# Access Compliance Report

### (Curb Ramps)

Intersection ID: 44065	Main Street: WOODS_CORNER_CT	Cross Street: SEDGEMOOR_LN	Location: W
ADA ID: 4C69528B6E13	Ramp Type: PerpDiag	Initial Pass/Fail: Fail	Overall Compliance: No
Severity Score: 47.5			
Codes/Mitigation Info/Possible Solution		Field Measurements/Component Compliance

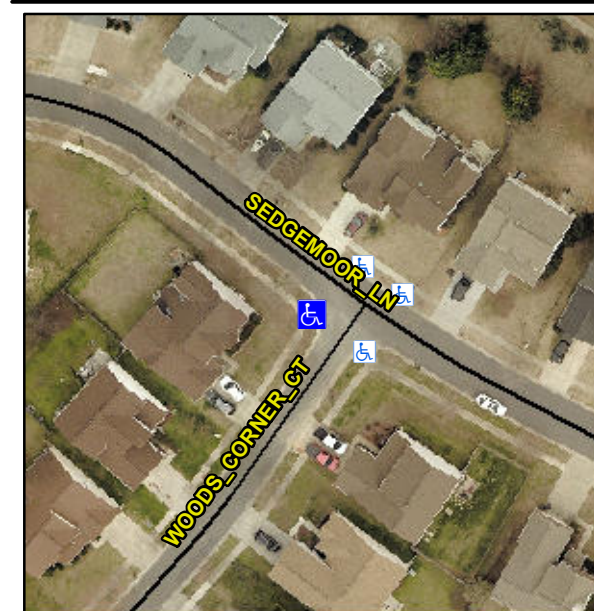
**Remove & Replace Curb Ramp With Two New Directional Ramps or Equivalent.**

**R304.5.1, R304.2.2**

Compliance	Description	Data	Compliance	Description	Data
N/A	Ramp Length (in)	73.5	No	Ramp Slope (%)	8.8
No	Ramp Width (in)	25.0	Yes	Ramp XSlope (%)	1.2
N/A	Flare Type LT	N/A	N/A	Flare Type RT	N/A
N/A	Flare Slope LT (%)	N/A	N/A	Flare Slope RT (%)	N/A
N/A	Flare Traversable LT?	N/A	N/A	Flare Traversable RT?	N/A
N/A	Landing Length (in)	N/A	N/A	DWS Provided?	N/A
N/A	Landing Width (in)	N/A	N/A	DWS Contrast?	N/A
N/A	Landing Slope (%)	N/A	N/A	DWS Length (in)	N/A
N/A	Landing X Slope (%)	N/A	N/A	DWS Full Width?	N/A
N/A	Landing Curb? (Y/N)	N/A	N/A	DWS Offset (in)	N/A
N/A	Shared Landing?	N/A			
N/A	Gutter Ponding?	N/A	N/A	Gutter Slope (%)	N/A
N/A	Gutter Lip Ht (in)	N/A	N/A	Gutter X Slope (%)	N/A
N/A	Painted X Walk1?	No	N/A	Painted X Walk2?	No
	X Walk 1 Direction	To SE		X Walk 2 Direction	To NE
N/A	X Walk 1 Width (in)	N/A	N/A	X Walk 2 Width (in)	N/A
	X Walk 1 Slope (%)	0.3		X Walk 2 Slope (%)	3.9
	X Walk 1 X Slope (%)	0.2		X Walk 2 X Slope (%)	1.1
